Historic Preservation Board Agenda

**PUBLIC HEARING
11 – 13 LEWIS STREET**

Application For: Certificate of Appropriateness for Exterior Alterations

Address: 11 - 13 Lewis Street

1 | SOUTH ELEVATION - DEMO WORK AT STAIR ENTRY

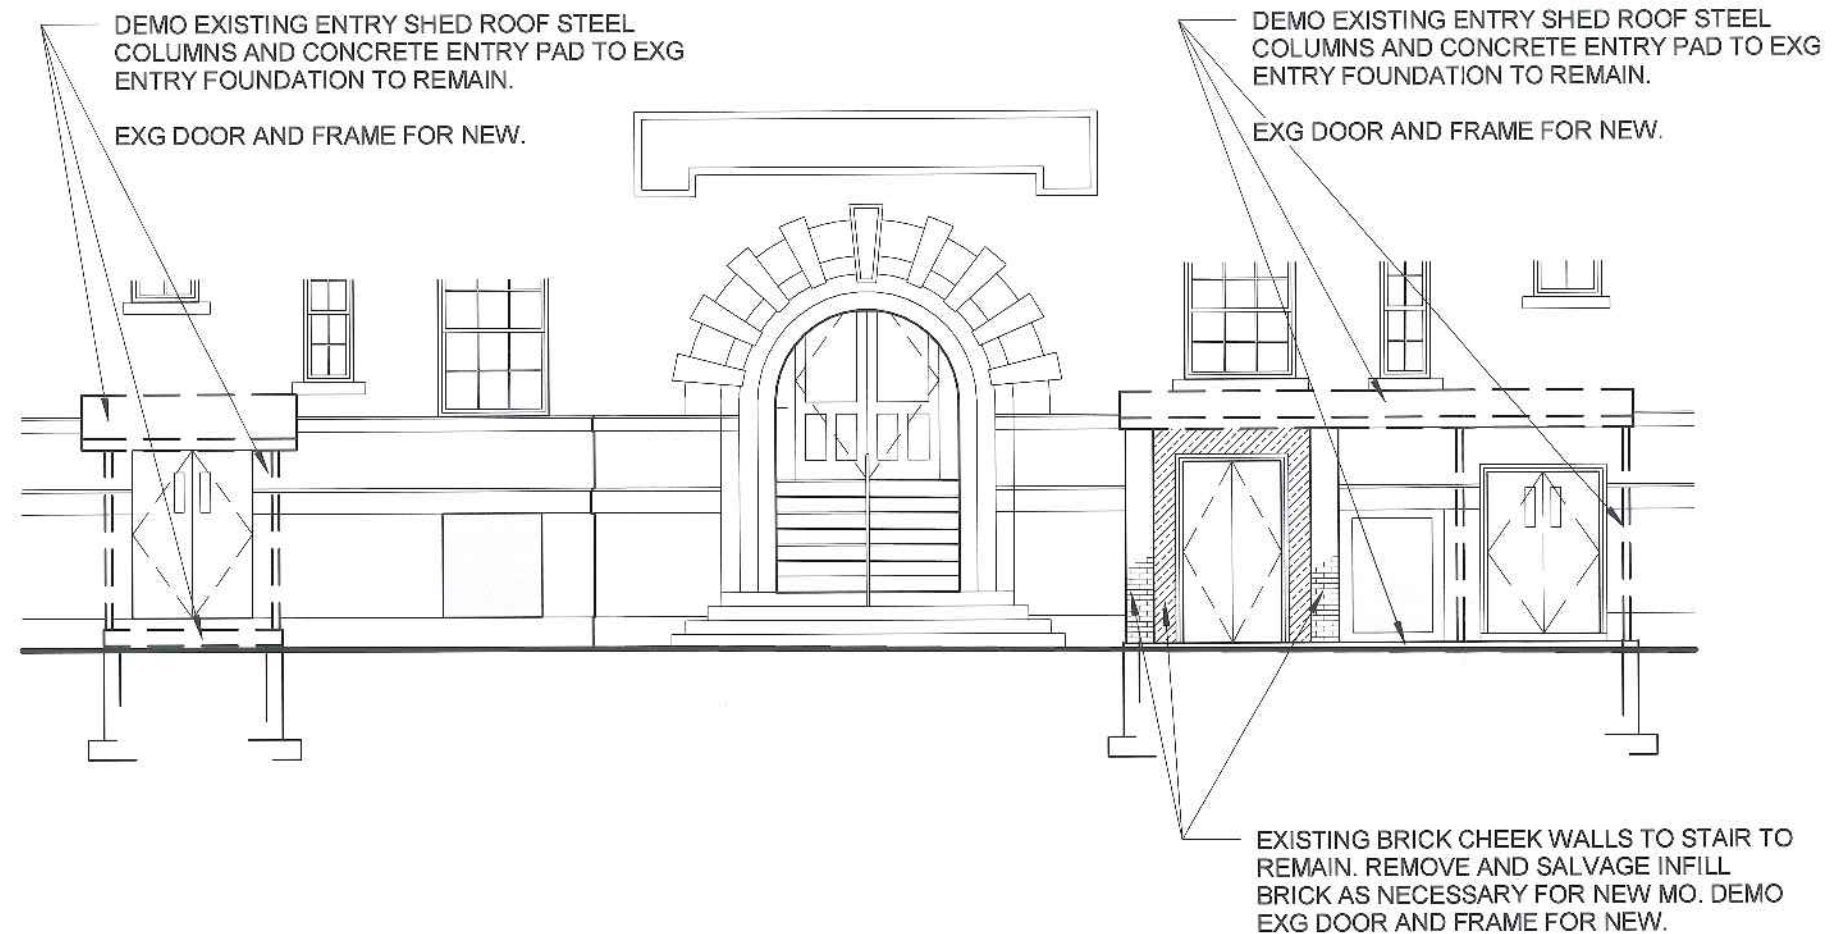
1. Site lighting plan and fixtures. Please refer to attached drawings and lighting cuts.
2. We have removed the modern shed like additions on the south elevation and redesigned in kind to the original design elements as recorded on the John Calvin Stevens drawings from 1907. See attached copies of original drawings and modified version by Archetype.

2 NEW HANDRAIL ELEVATION - NORTH

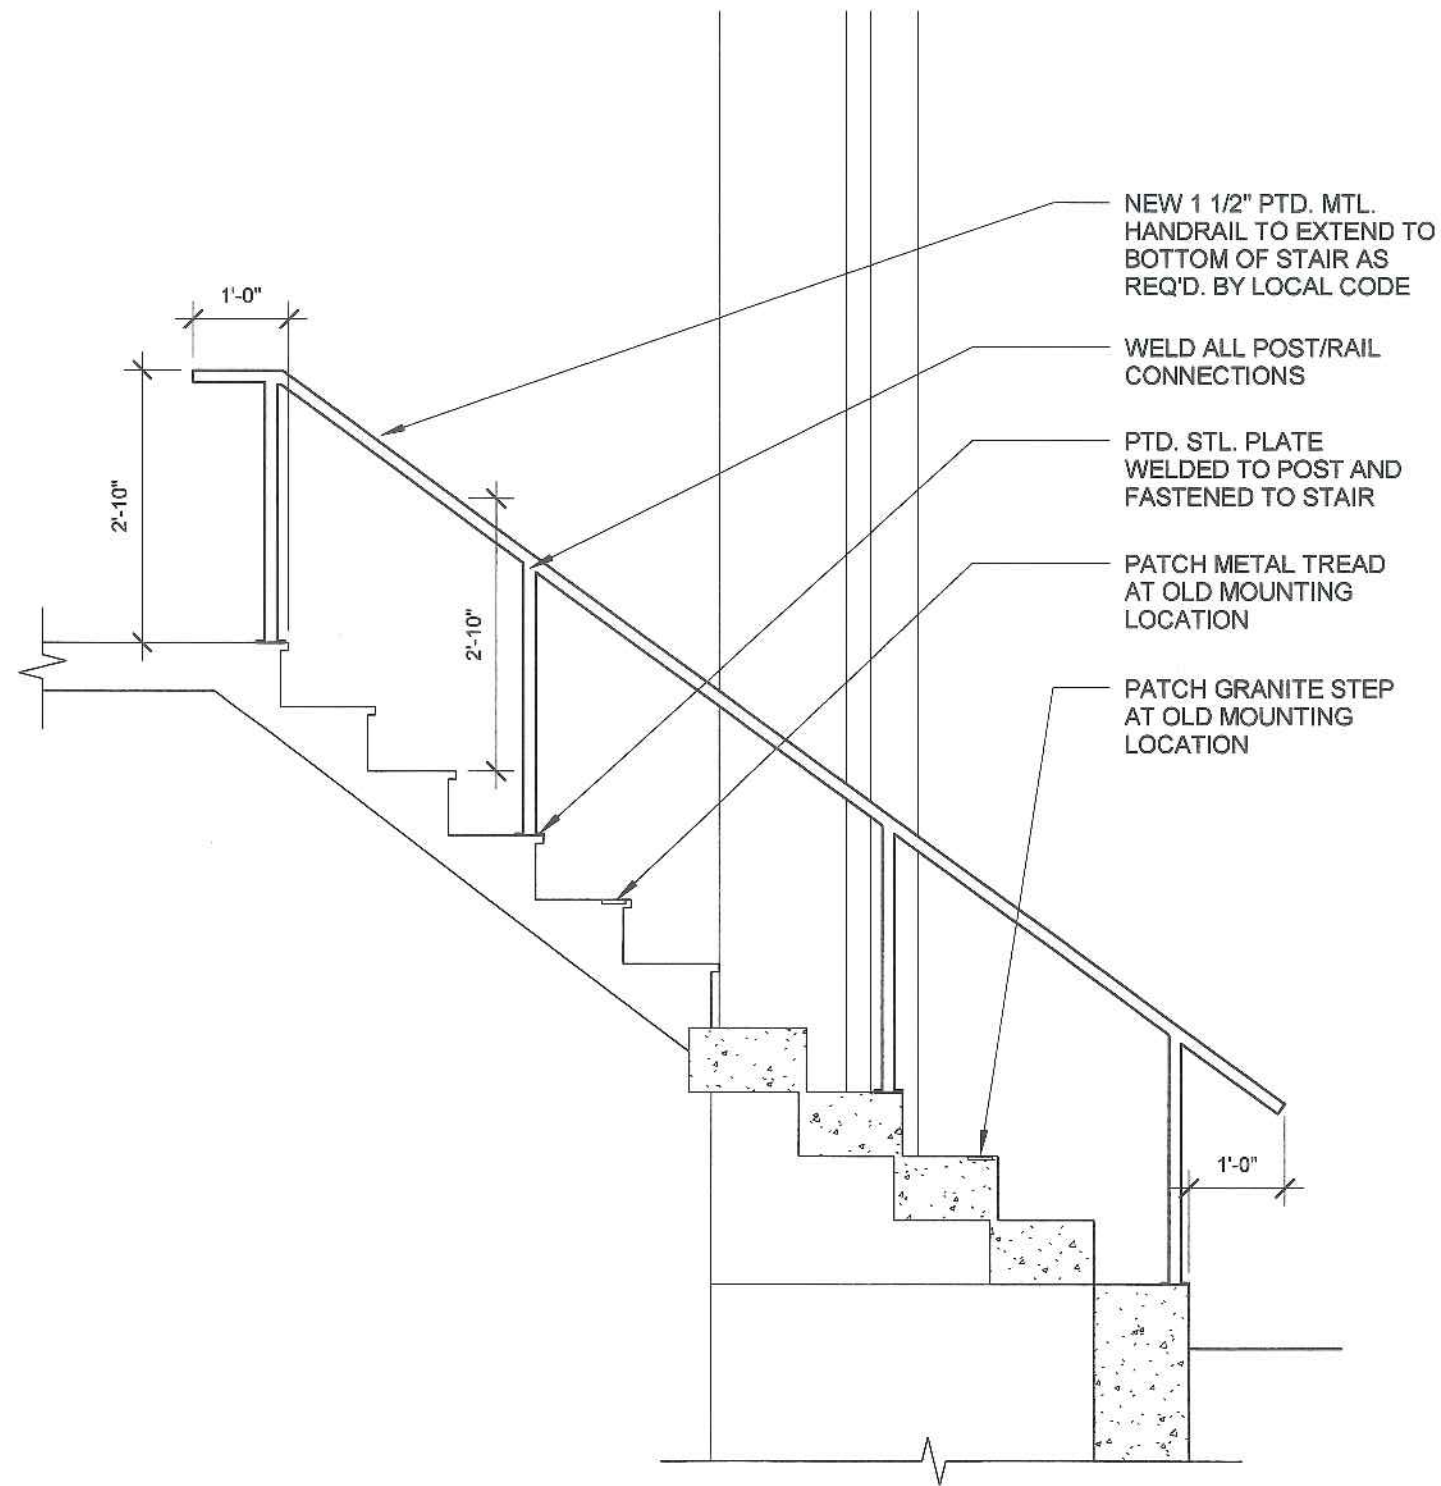
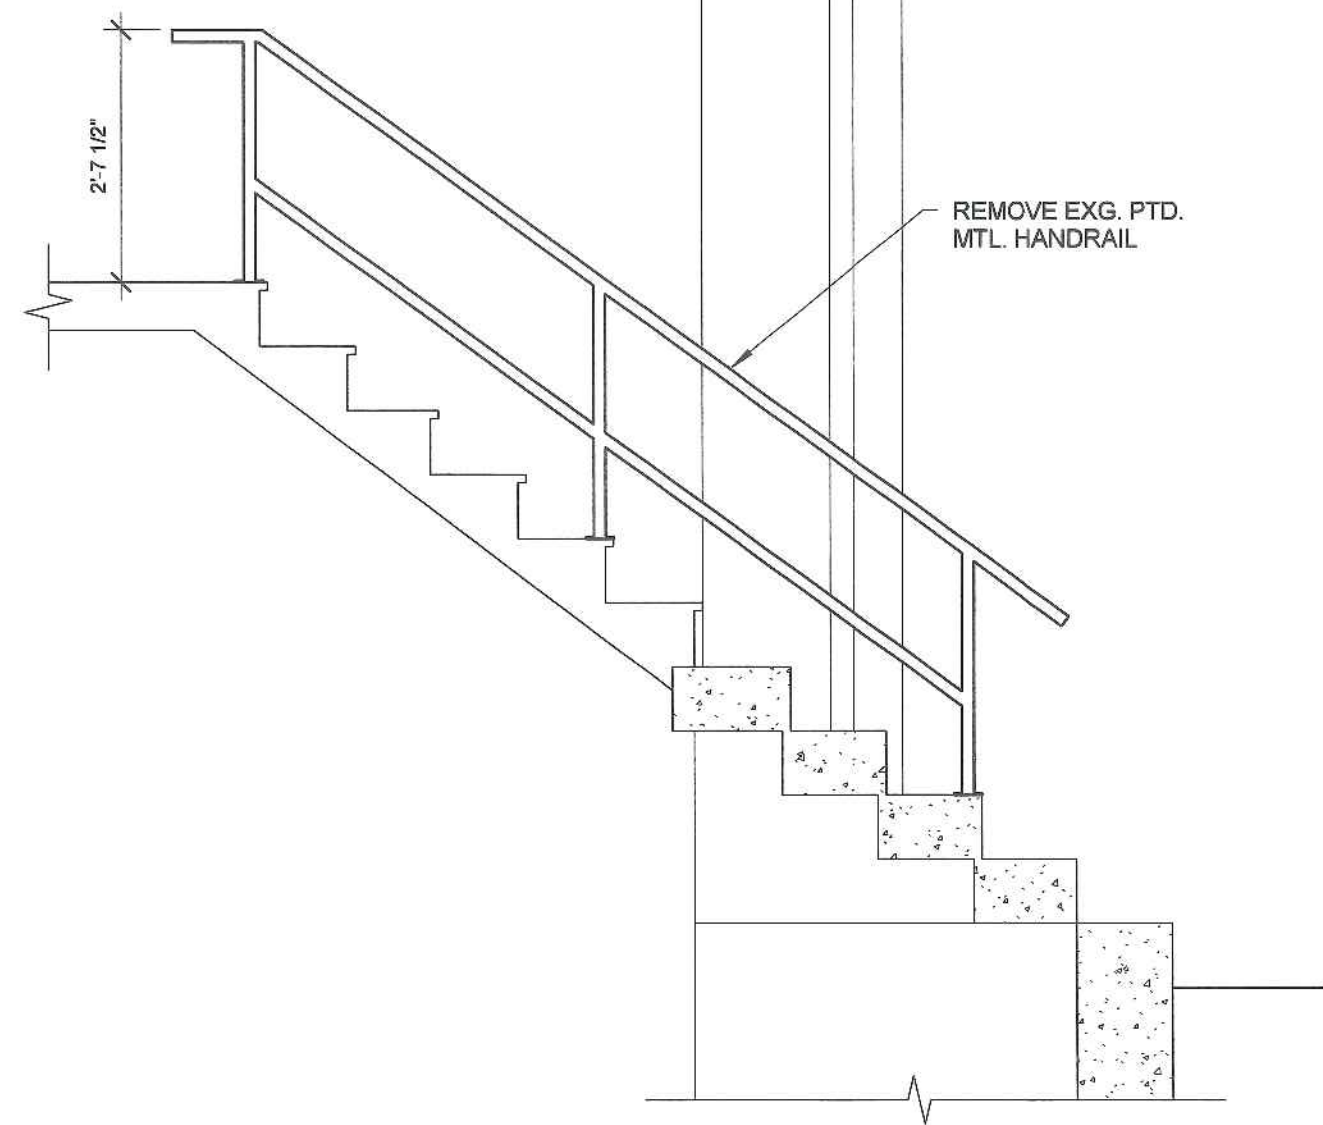
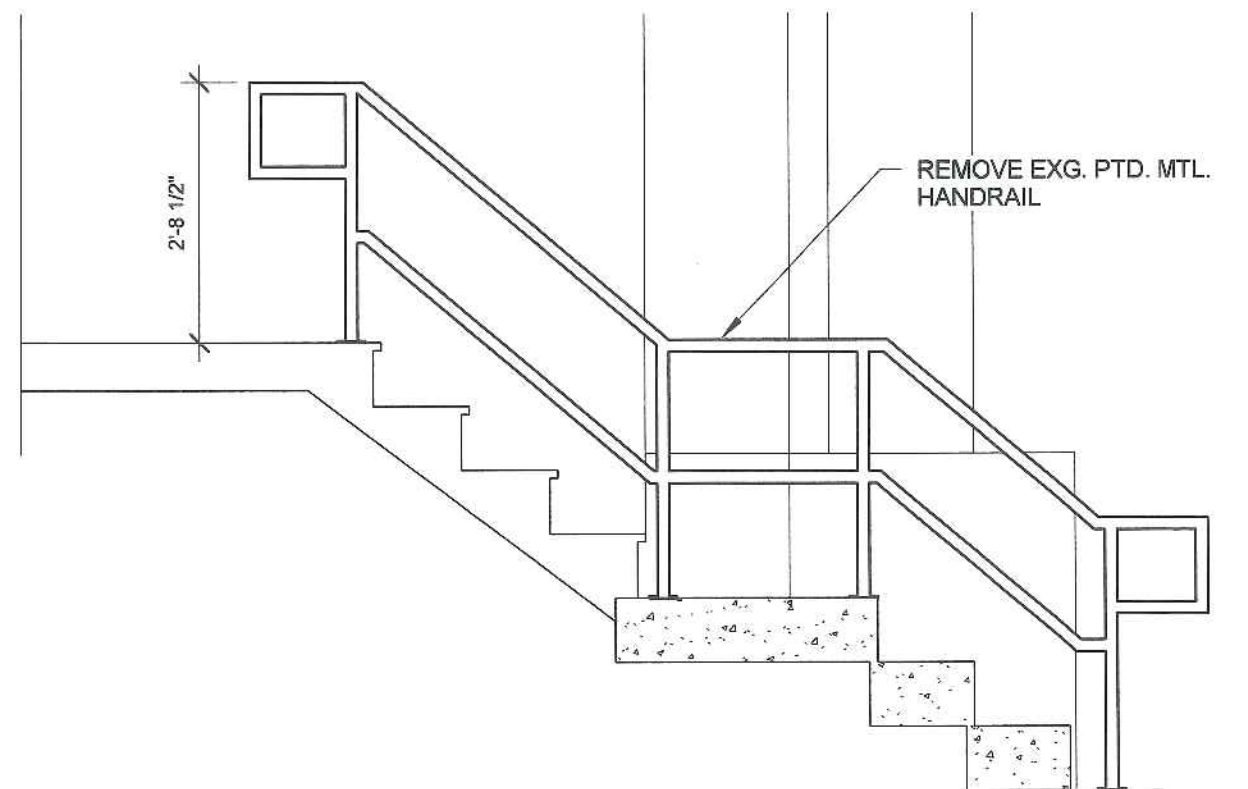
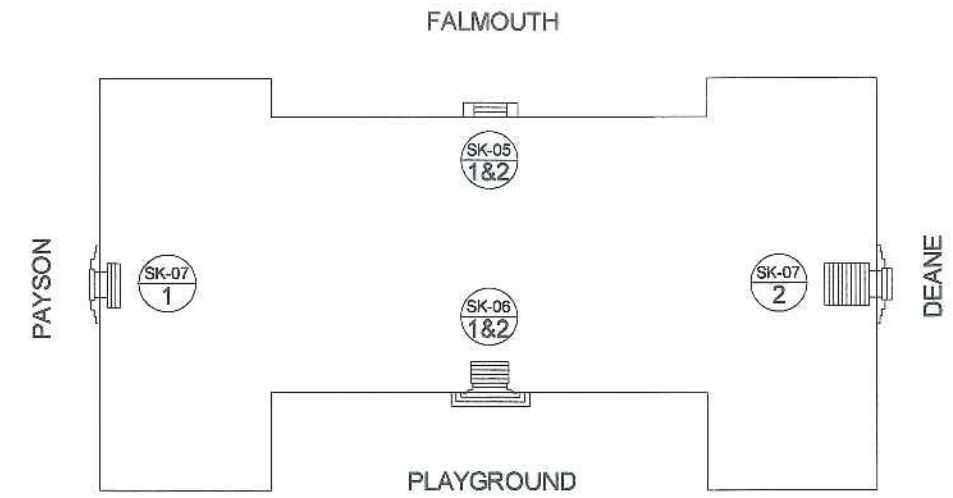
3. We have detailed railings to be added to exterior stairs. Based upon conversations with our historic consultant we have designed a very simple steel rail, painted black. Also please note that the original drawings do not show railings at the bottom run of stairs and there appears to be no indication that rails were ever installed previously. See attached first floor plan and railing details.

HP - 1.2

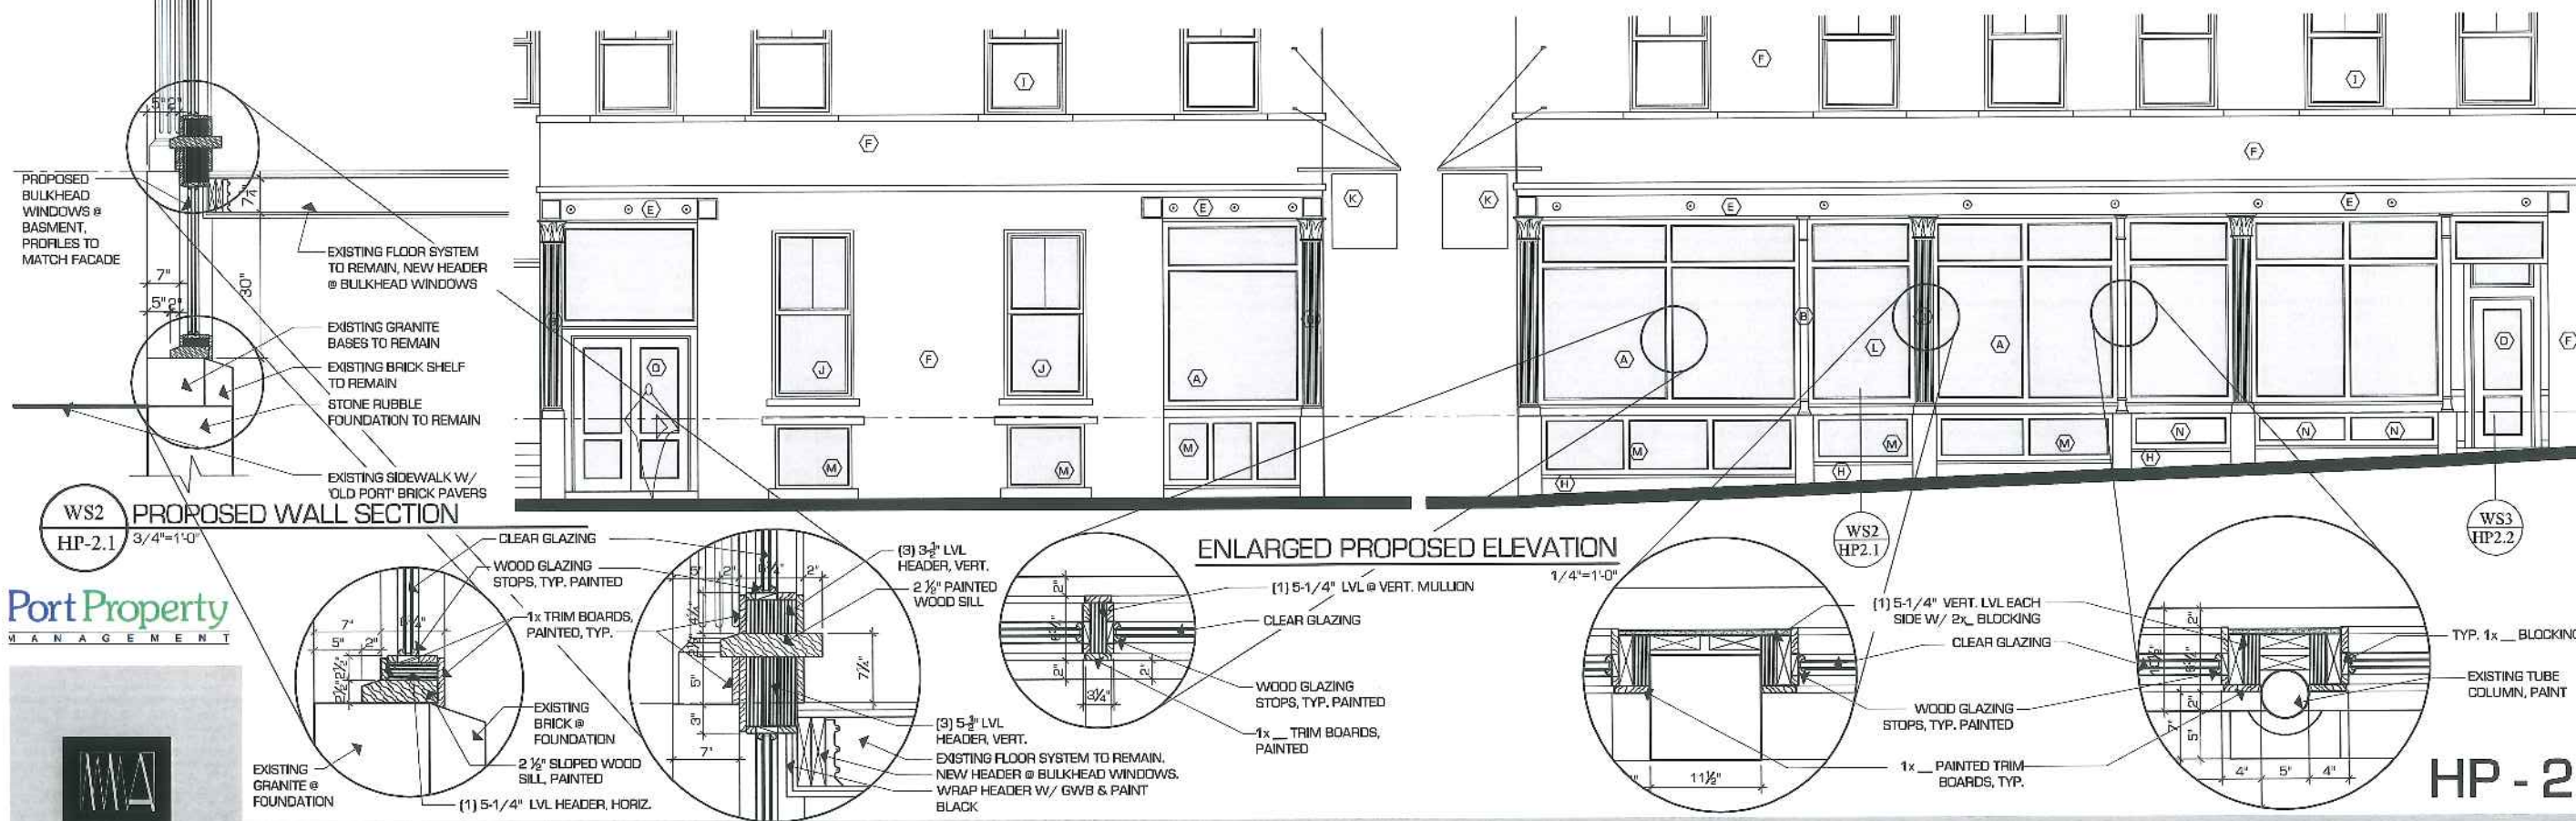
A couple of specific observations with respect to the bulkheads and basement windows: On the Milk Street elevation, staff suggests that a single vertical muntin be added to the two basement windows to the right of the building entrance. This will provide better scale to these window openings and help relate these openings to the bulkhead treatment at the corner. On the Market Street elevation, the subdivisions shown in the large bulkhead bay at the corner might warrant further study.
